3d Community Church

659 Graham Rd Sanford, NC

9/3/25

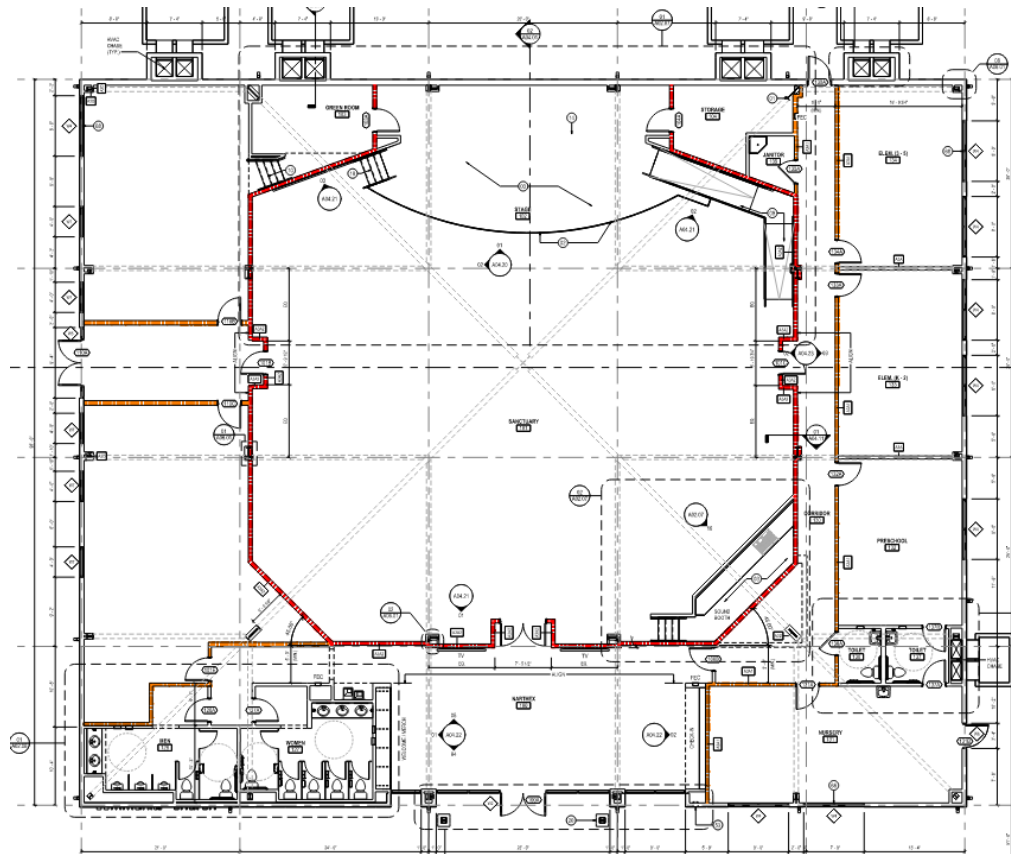
General contractor shall extend the one and two-hour fire rated wall framing and sheetrock tight to the roof insulation/tarp system. Apply fire caulk at the top of sheetrock. Allow deflection at the roof structure. — Follow UL Designs UL419 and V449. Provide top of wall condition at rated walls indicated in red and orange below.
